Informal document **GRB-64-02**
(64th GRB, 5-7 September 2016,
agenda item 2)

Editorial amendments to ECE/TRANS/WP.29/GRB/2016/4

Regulation No. 28, amend to read:

"Uniform provisions concerning the approval of audible warning devices and of motor vehicles with regard to their audible warning signals

Figure 1

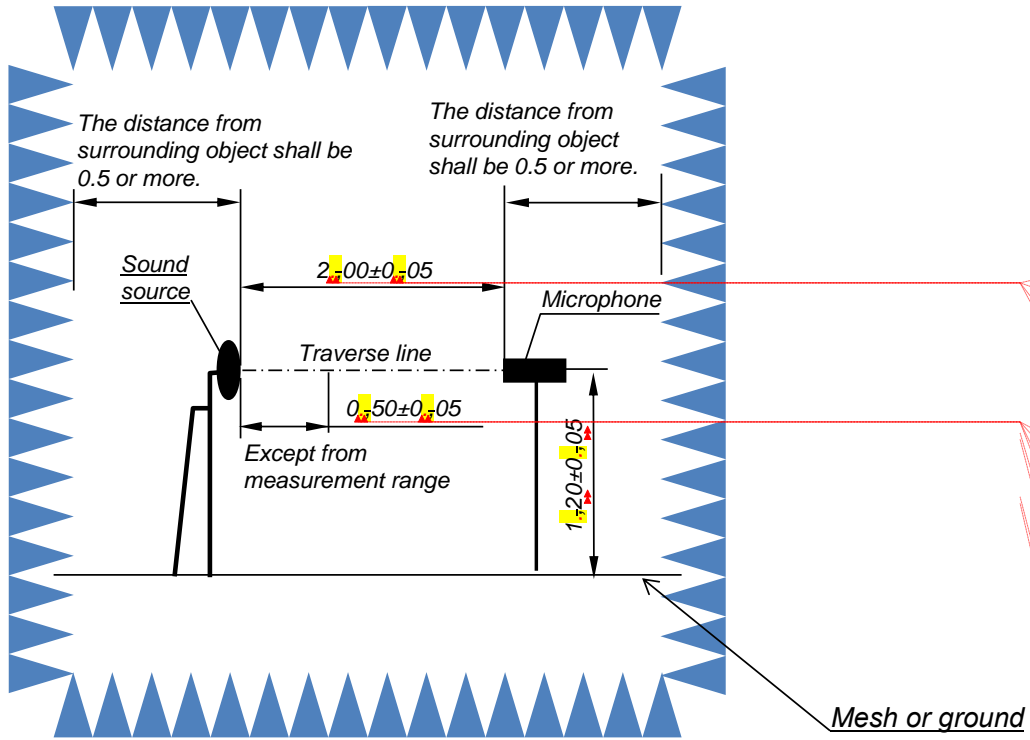
- A minimum of 10 points shall be used for evaluation on the microphone traverse line. The measurement shall start at 0.5 ± 0.05 m from the sound source, and spacing shall be 0.15 m (e.g. Figure 1);

Microphone positions for measurements of acoustics parameters of audible warning device, audible warning system, multiple audible warning system

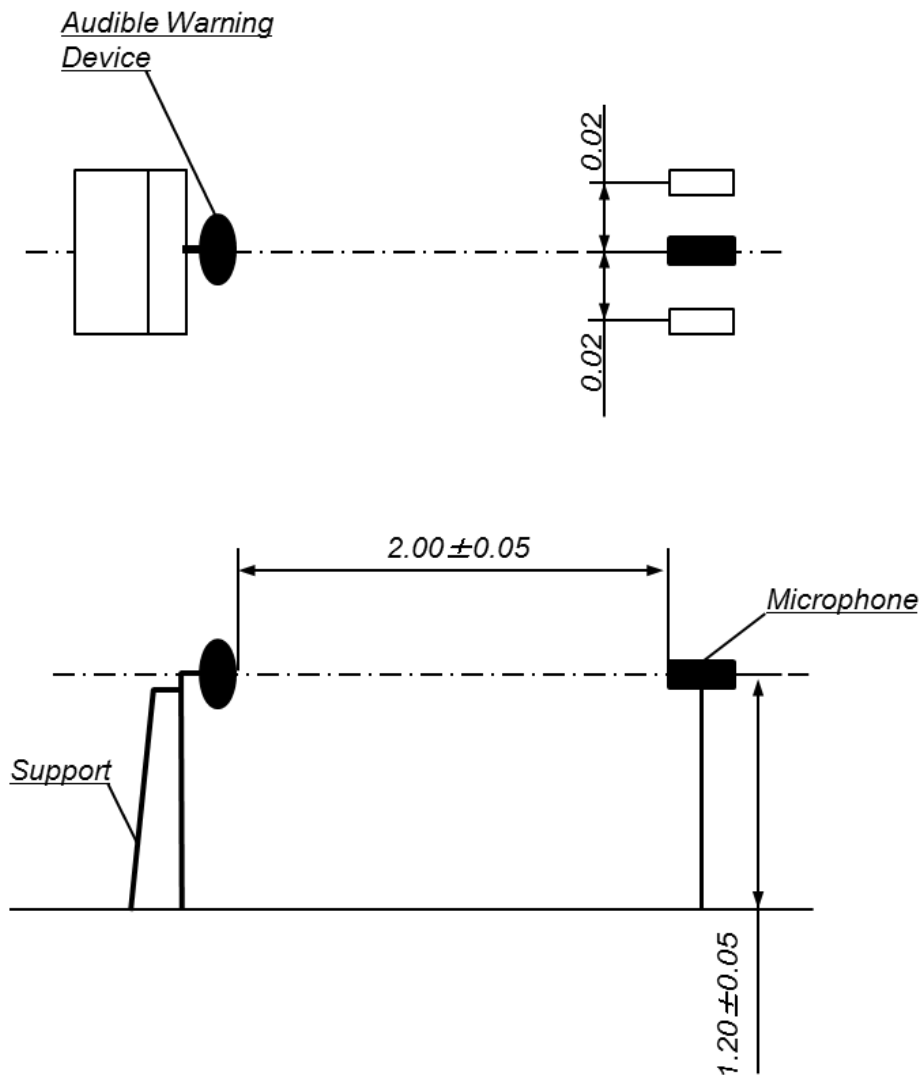
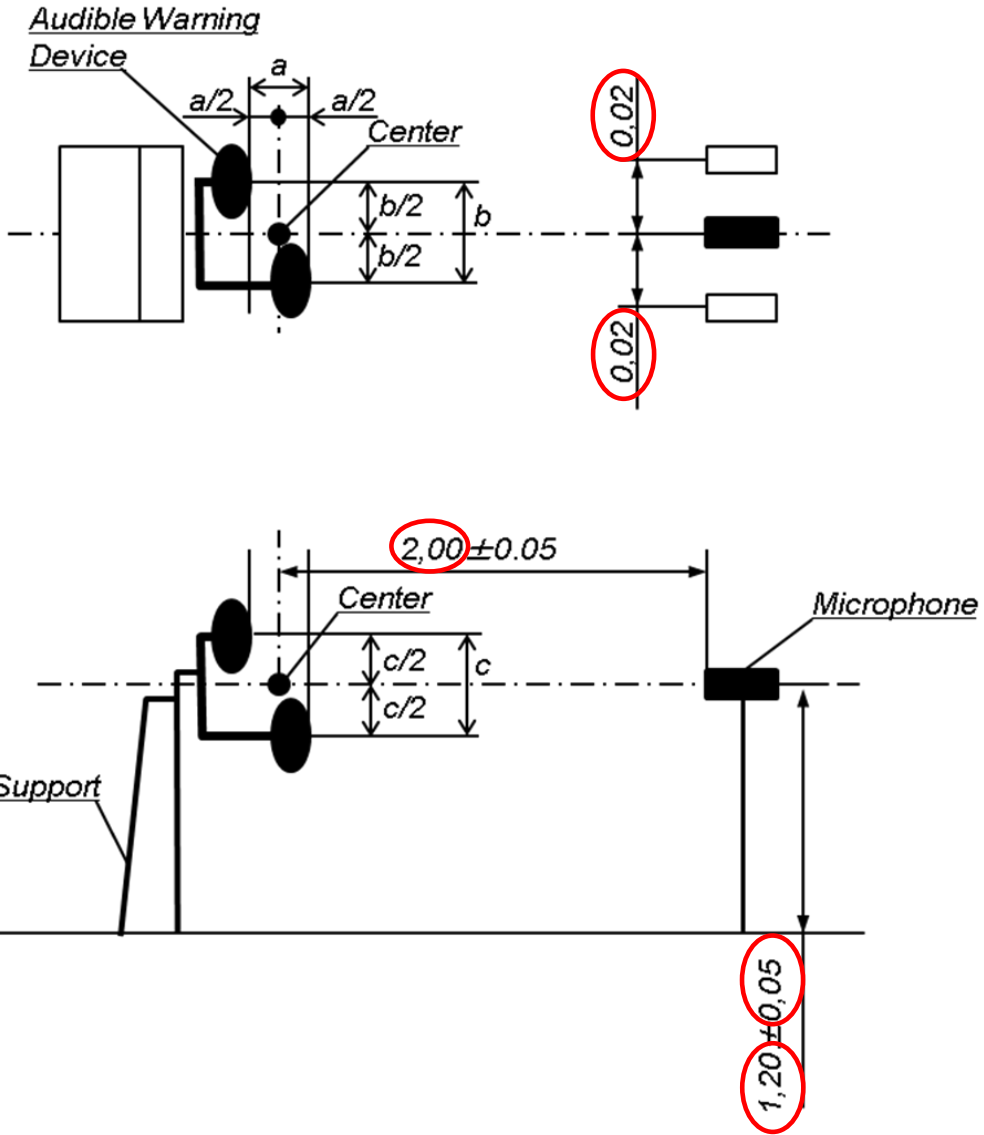
Please make corrections “,” to “.” for decimal point in the figures below.
